BAR Meeting  
September 16, 2015

**ISSUE:** Permit to Demolish/Capsulate and Certificate of Appropriateness (dormers)

**LOCATION:** 119 Queen Street

BAR2015-00224 & BAR2015-00225

**Dormers Side Face Elevations**

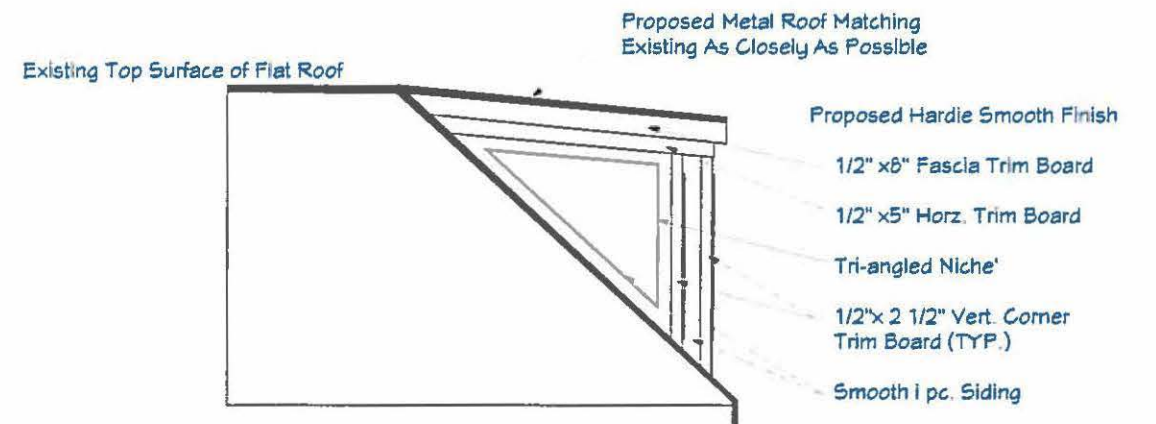
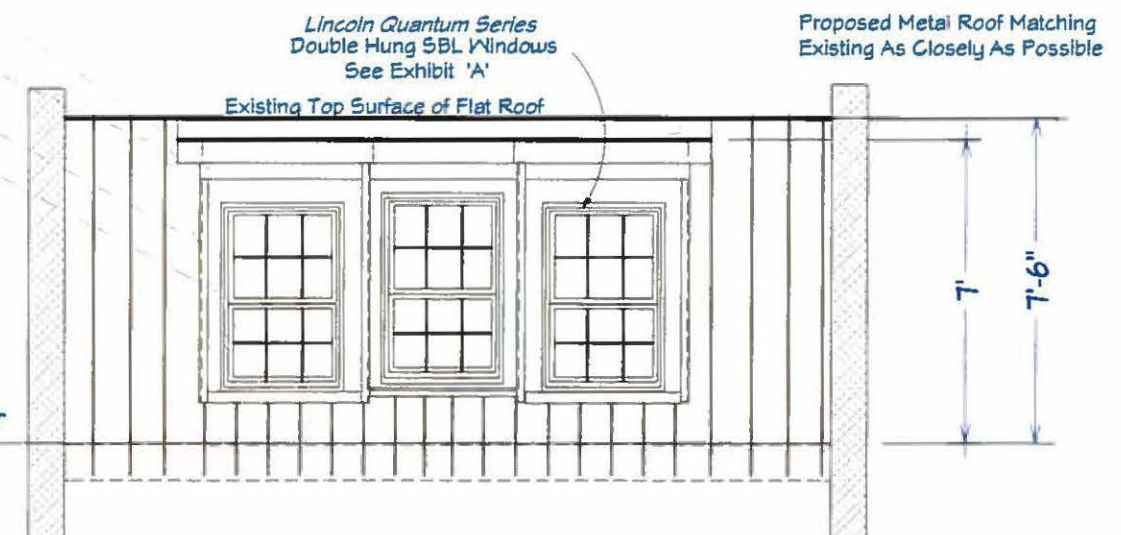
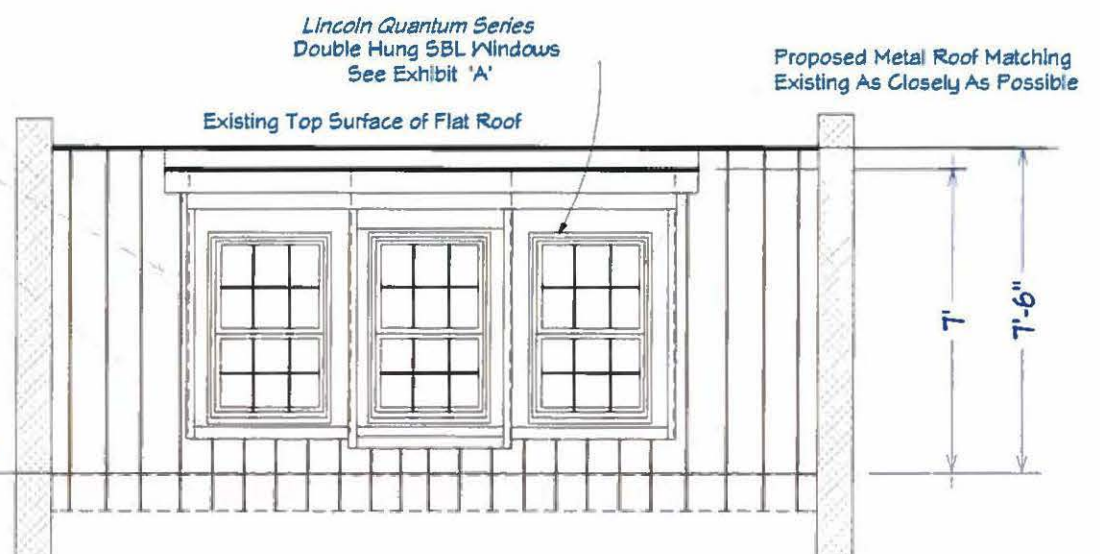
Both shed-style dormers will have three six-over-six, double-hung windows. The center window on the front dormer will project beyond the flanking windows, while on the rear elevation the center window will be slightly inset. The materials on the dormer will be smooth Hardie brand fiber cement plank siding and trim, and the roof will be clad with standing seam metal to match the existing roof.

The proposed double-glazed, aluminum clad wood windows on the all of the dormers will be manufactured by Lincoln (Quantum Series) and will have simulated divided lights with 7/8" muntins. The dormer materials will be painted to match the existing color scheme on the townhouse.

The rear dormer will be minimally visible from North Lee Street and the front dormer will be visible from both Lee and Queen Streets. The proposed new dormers will utilize synthetic materials, such as Hardie plank brand fiber cement siding and trim. While the *Design Guidelines* cite a preference for authentic materials, Staff has no objection to the use of the synthetic materials in this case as the dormer will not be accessible to the public and will be viewed from a distance. Further, it is the general practice of the Board to permit the use of modern and sustainable materials on new additions and new construction, particularly dormers where the elevated location makes maintenance more difficult. The applicant also proposes, and staff supports, the proposed Lincoln aluminum clad, simulated divided light windows, as the Board's *Window Policy* support the use of aluminum clad wood, wood composite or fiberglass windows on building constructed after 1969.

Staff reluctantly supports the proposed dormer as it is consistent with dormers regularly approved by the BAR for attic conversions on the late 20<sup>th</sup> century townhouses in this particular development in the historic district. Should the BAR approve a shed dormer on the front of this townhouse, Staff asks that the Board provide guidance in the motion that differentiates the use of shed dormers on these dwellings from other buildings in the historic district.
